CME1202R & CME1402R SERVICE PARTS

SERVICE BULLETIN

Subject: CME1202 and CME1402 control circuit enhancement.

Kit Wiring Detail

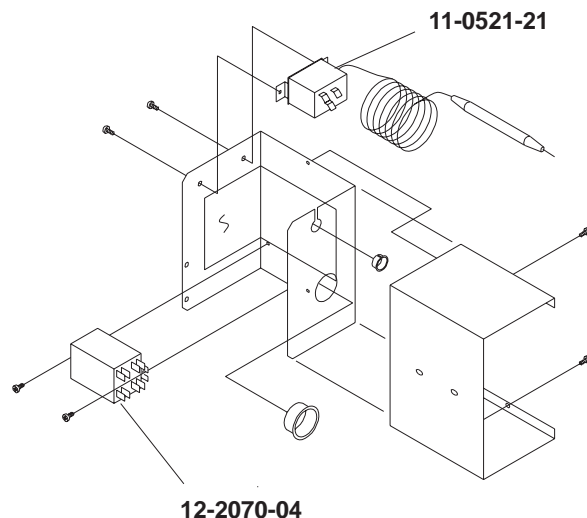
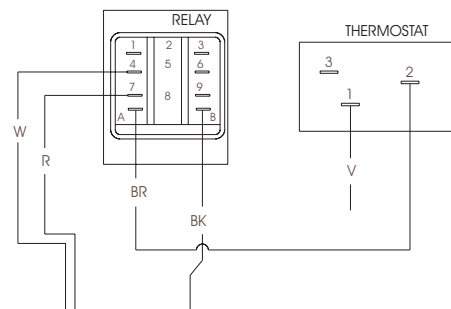
Beginning with May 1997 production (-11N), a thermostat and relay will have been added to all versions of the above two models. The benefit of this enhancement is that it greatly reduces the impact of ambient temperature changes - machines with this circuit will automatically adjust the harvest cycle length as needed to release all ice.

The thermostat and relay form the working components of a new circuit that, under certain low temperature conditions, by-passes the timer during the harvest cycle. The the timer still operates as it has, except when the low temperature conditions are present.

There is a kit available to add this part to any prior CME1202, CME1402, CMS1202 or CMS1402. The part number is: **A37281-020**.

When the unit is harvesting under low temperatures, the thermostat, sensing the inlet tube of the accumulator, will be closed. This connects power to the relay coil, which then closes contacts 7-4, which parallel and by-pass the plug-in finish relay contacts 9-3. When this happens the timer motor will stop at the end of its normal harvest time but the machine continues to harvest until the suction line temperature warms up and the thermostat opens, cutting power to the relay coil and breaking the by-pass circuit. In effect, this means that the timer always determines the MINIMUM harvest time, and, when conditions are cold, the new control circuit determines the MAXIMUM harvest time, which will vary as needed.

Two service parts are available: The thermostat, its part number is: 11-0521-21 and it includes the clamps and screws needed to attach it to the suction line. The relay part number is 12-2070-04.

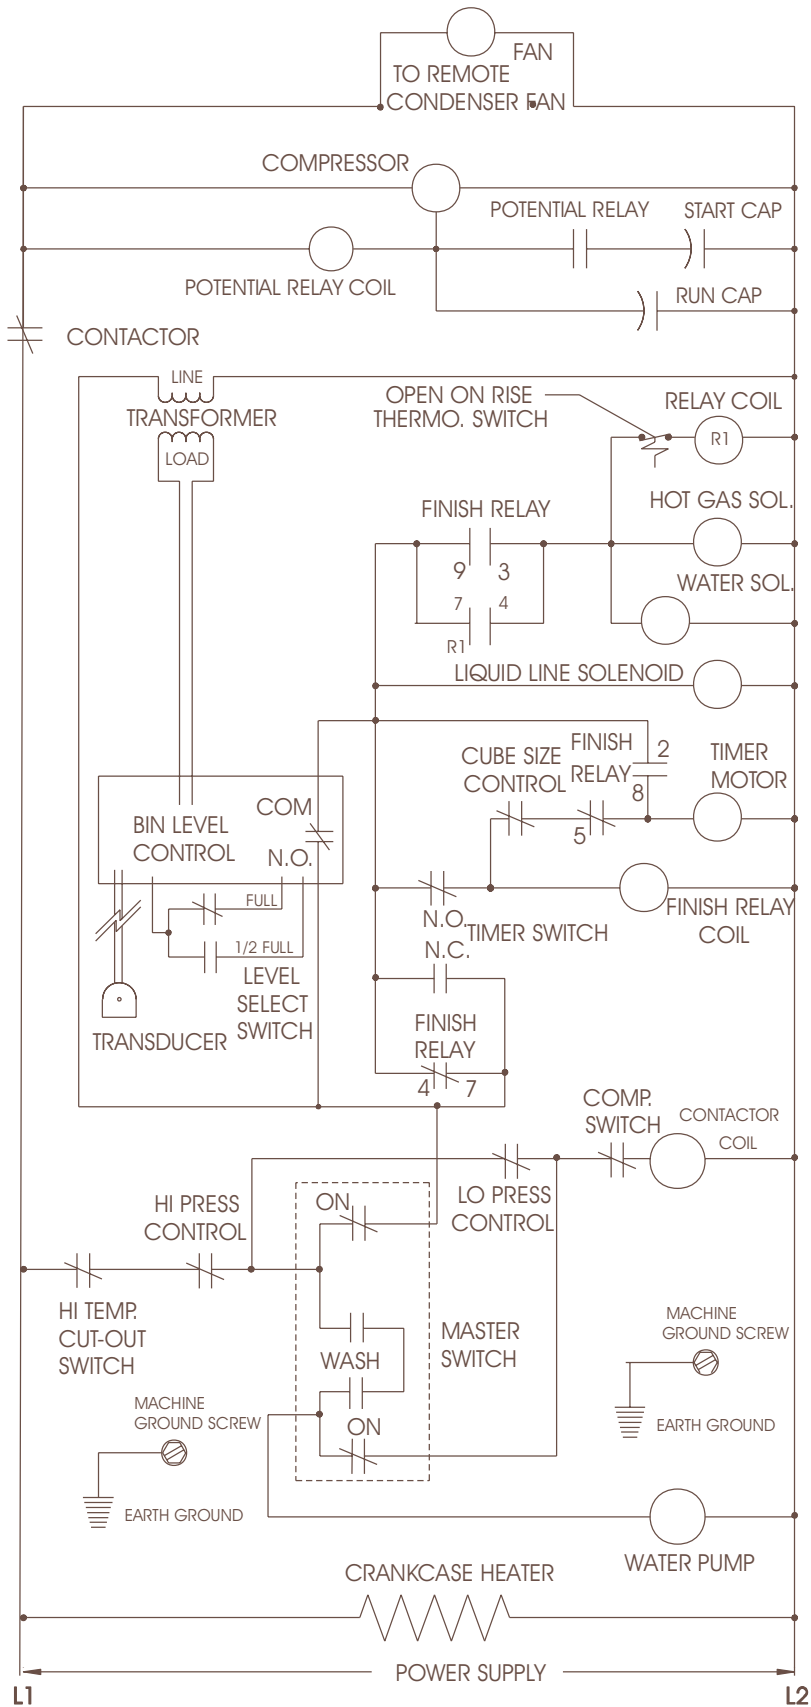
A schematic diagram of a single phase remote is on the back of this bulletin. Three phase will be similar.
